Landform 1 with RDI shift suggestion

Analysis of FL 19232 Visual Quality

Dr. Ken Fairhurst, RPF, RDI Resource Design Inc, was asked by Interfor Corporation to review the Visual Plan prepared for the proposed FL A19232 cutblocks 129 and 227. RDI has 20 years of progressive experience in all aspects of Visual Resource Management and Planning in all regions of British Columbia, and is highly-regarded as an independent advocate for excellence in the professional discipline of VRM.

Visual Impact Assessment
Bear Lake – FL A19232

Landform 1 with RDI Suggestion to be verified by Interfor
Map, Simulations and Percent Alteration Calculations by Interfor Corp.
Report Assembly and Analysis by RDI Resource Design Inc, December 21, 2015

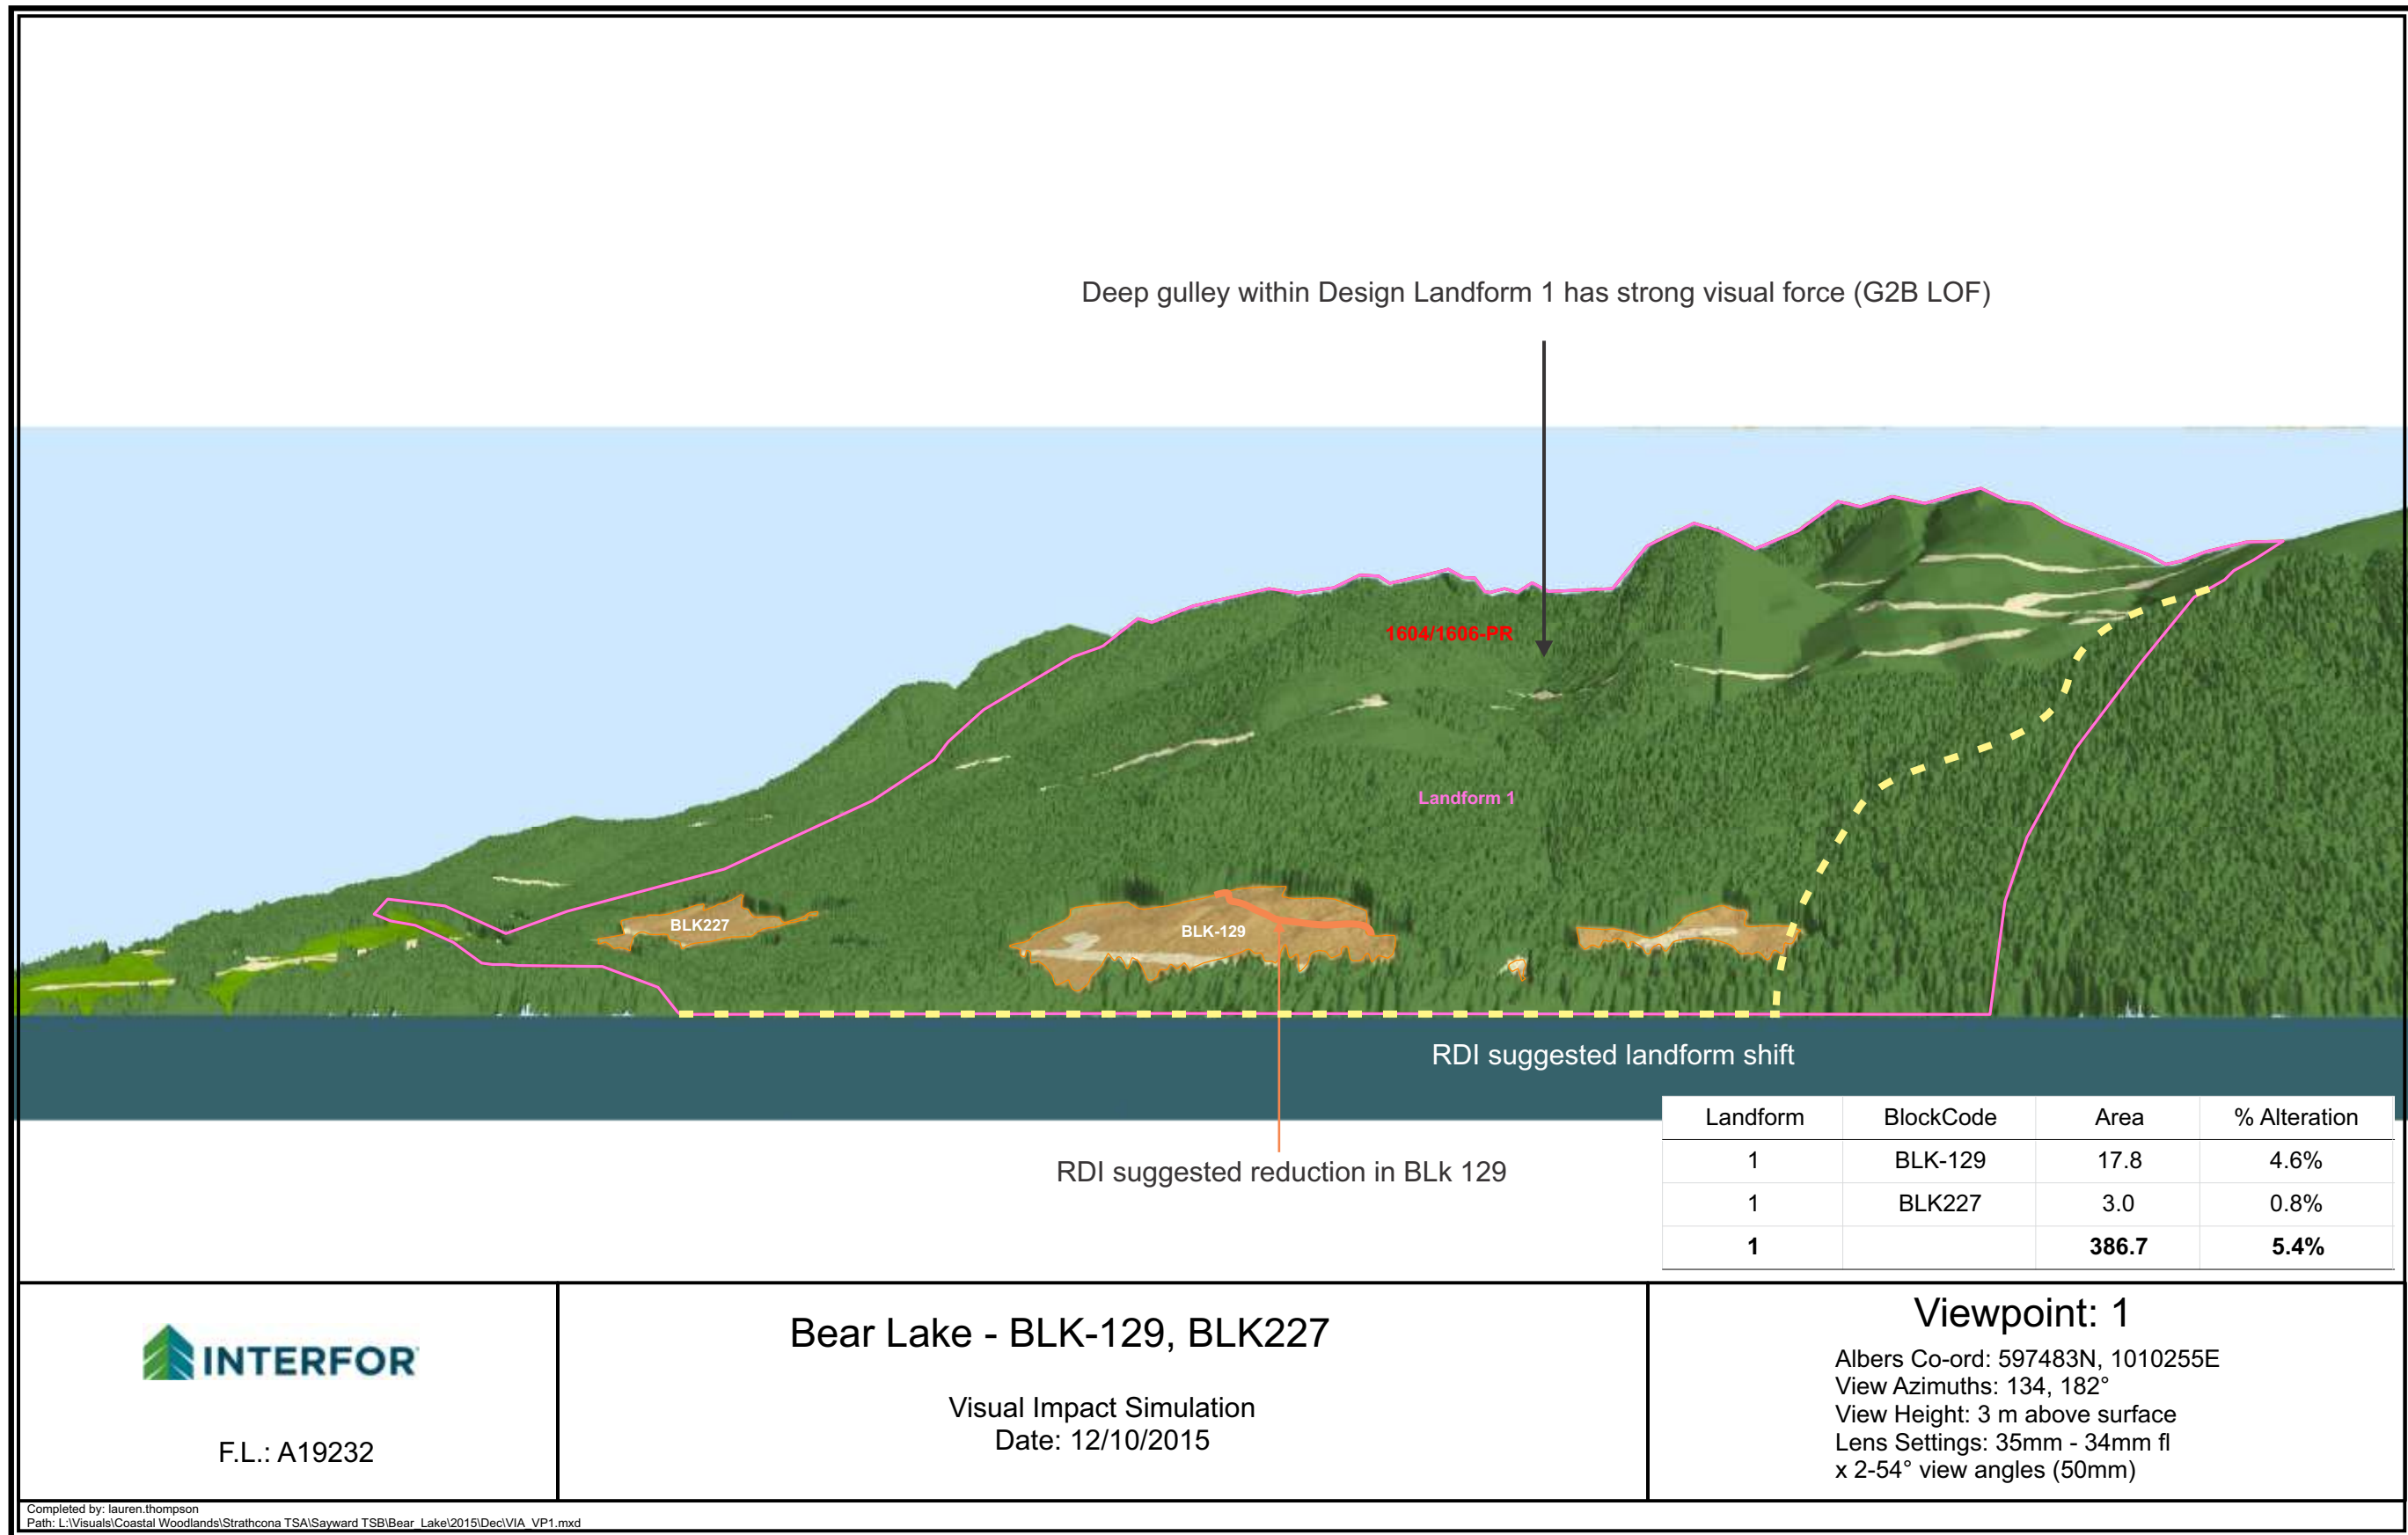
While RDI concurs with the Landform 1 assembly, it would prefer to see it utilize the immediately adjacent gullies (G1 and the LOF added by RDI: G7) rather than the vertical ridges as defining the east boundary (G1 LOF) and west boundary (just beyond the VSU 1610 edge – G7). The reason is that landforms complete themselves by rounding into the concavities rather than stopping at ridges. The dashed-line suggestions made by RDI in purple on the key map and in solid yellow on the iMAP BC map of complete VSUs shows the suggested adjustment. For clarity of understanding and verification, Interfor's cover map should reveal the VSUs and landforms to the height of land as shown in RDI's iMap.

Viewpoint 1 with Interfor Current Plan with RDI suggested adjustment in BLK 129 and Landform 1

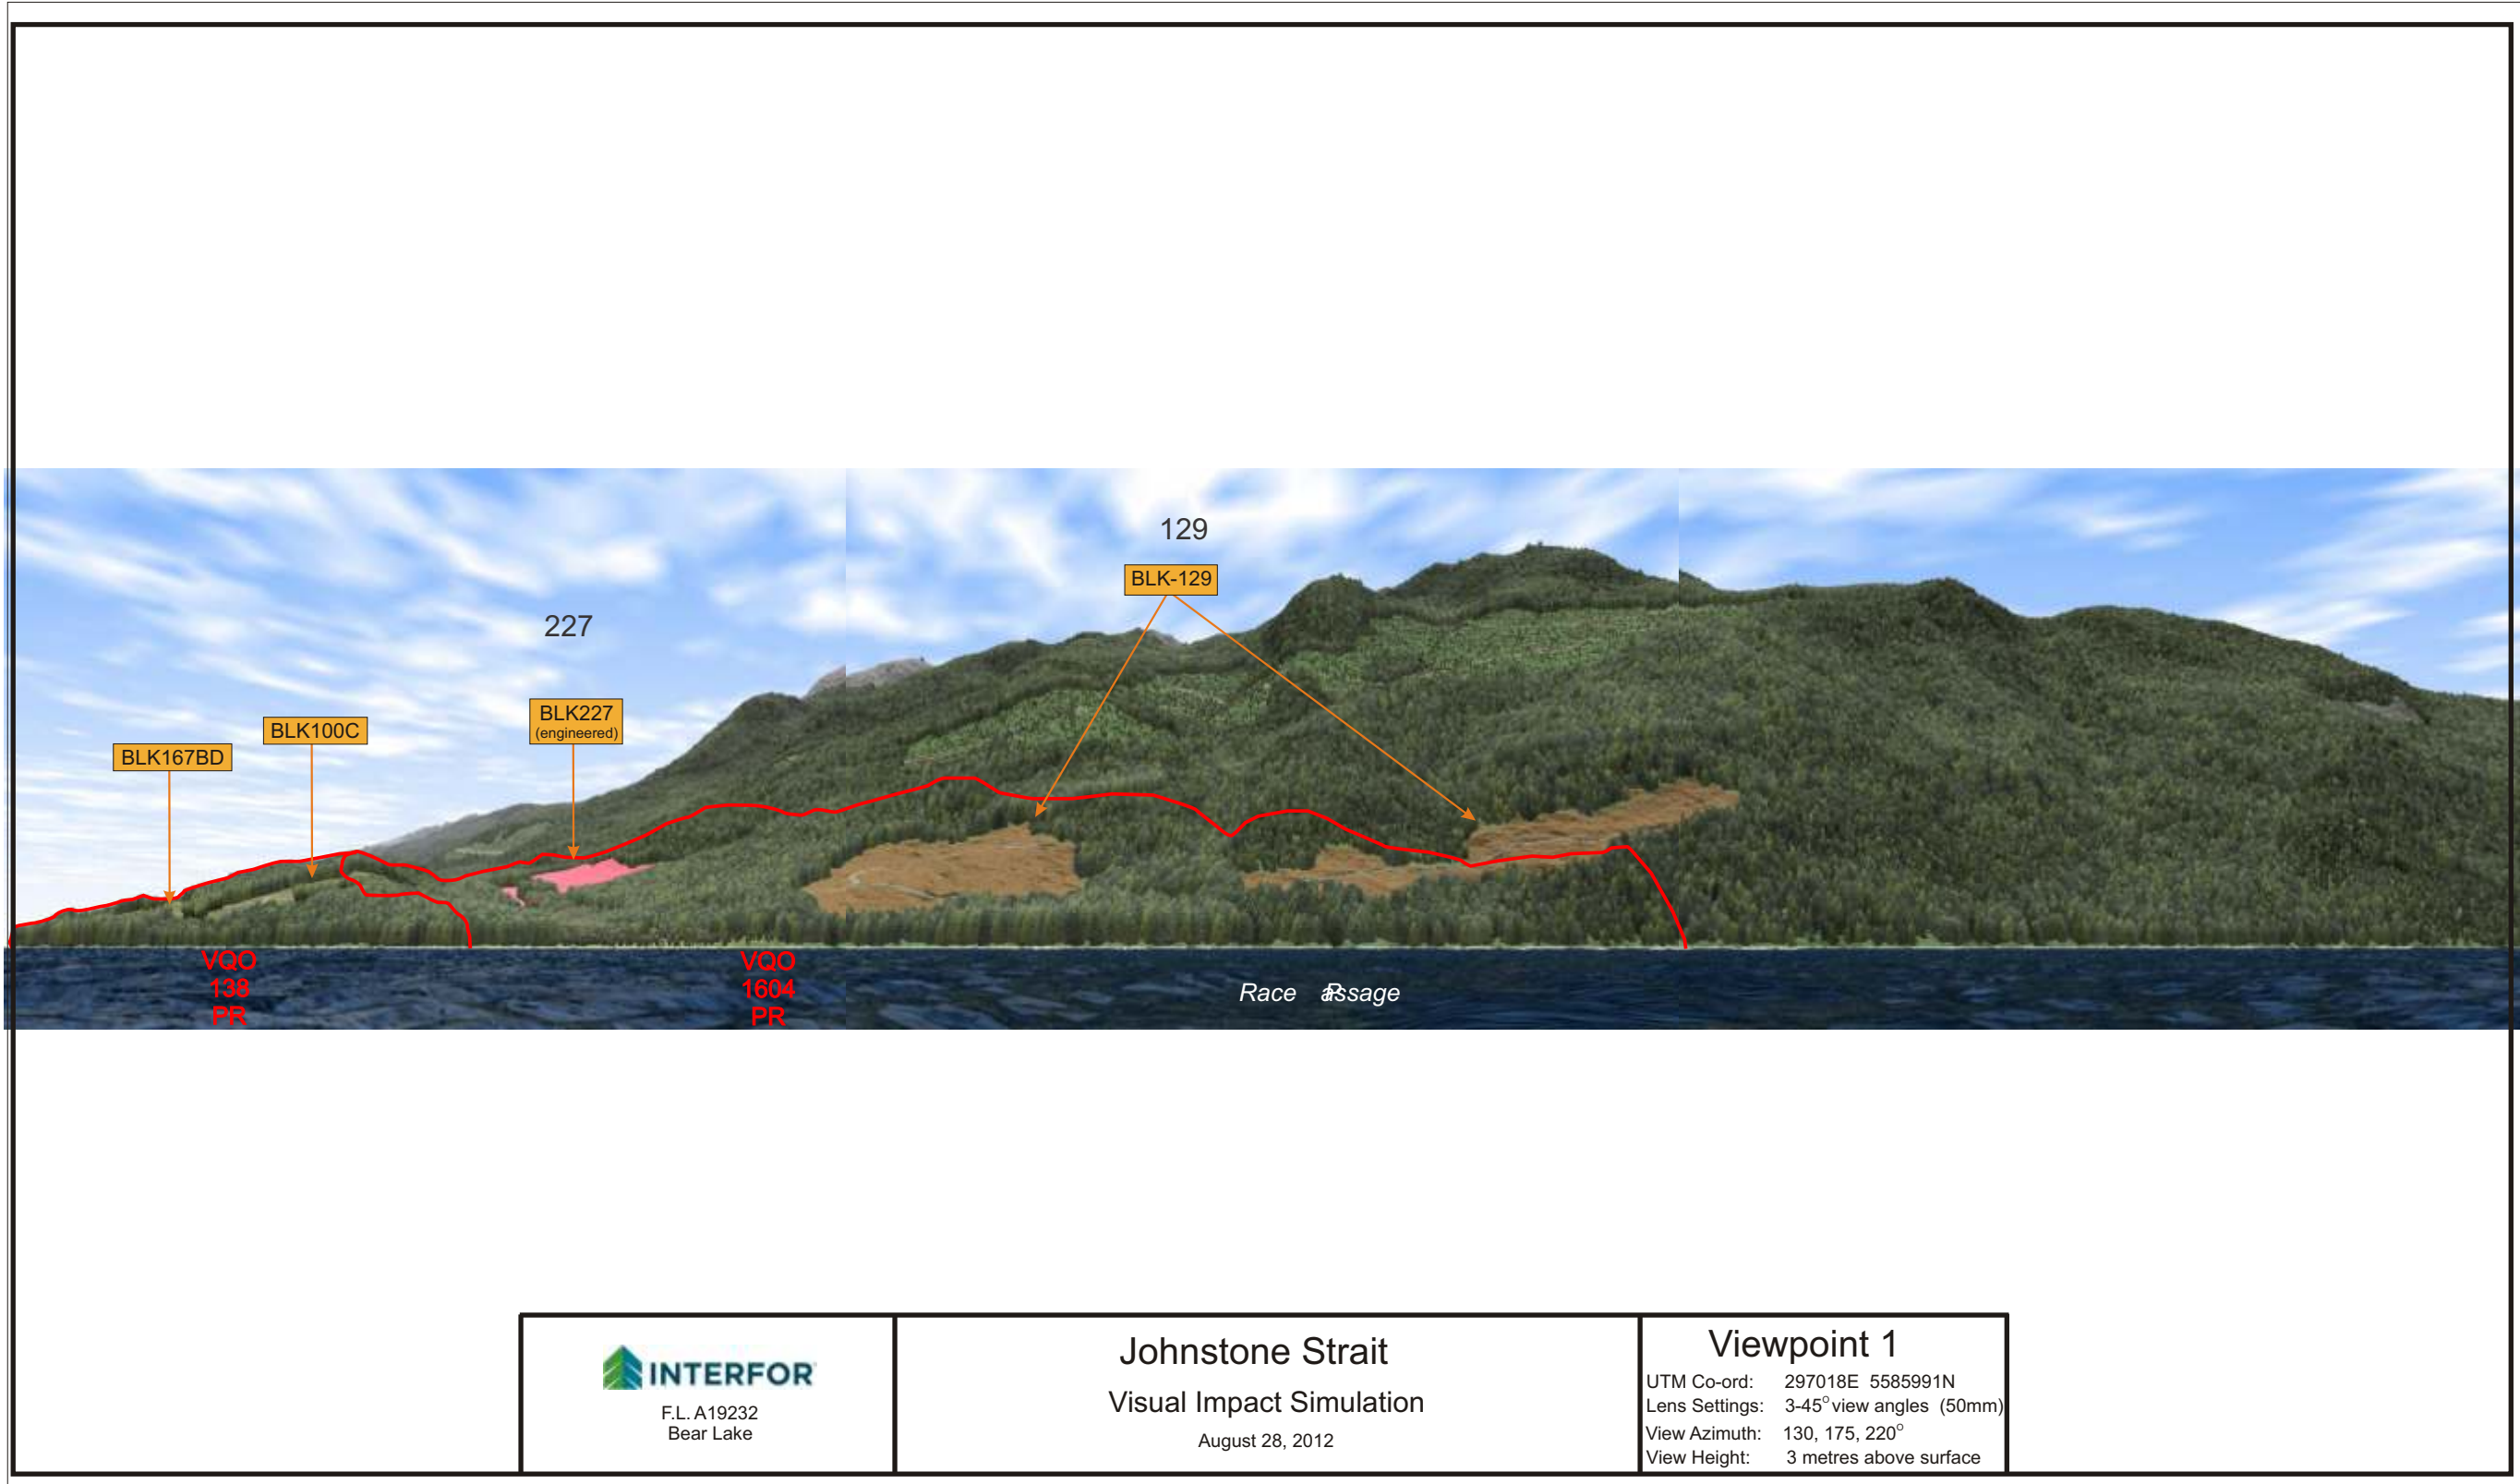
While the development is fairly accomplished in design, RDI would encourage a further look at the largest opening of cutblock 129 as seen from Viewpoint 1. The opening would climb from near the shore at about 20m elevation to nearly the 160m elevation over about a 400m run (verification requested). This creates a somewhat stark, open appearance and is centrally located in the view of the landform. It has neither the oblique view angle benefitting the much larger Block 227, nor the screening of the much smaller openings of Block 129. The opening exhibits only subtle responses to the LOFs (pushing up hollows; down convexities).

RDI's recommendation is to bring the upper southwest corner somewhat downhill as suggested by the orange line in the Viewpoint 1 simulation. Without the benefit of having the use of the 3D model for exact location, RDI remains unsure of the planimetric location of the suggested adjustment. By interactively tracing in perspective view with VNS to see the corresponding location in planimetric view, Interfor can produce a quick and simple approximation of line can be determined in VNS, which can then be exported to bring into ArcMap to refine the shape of the opening.
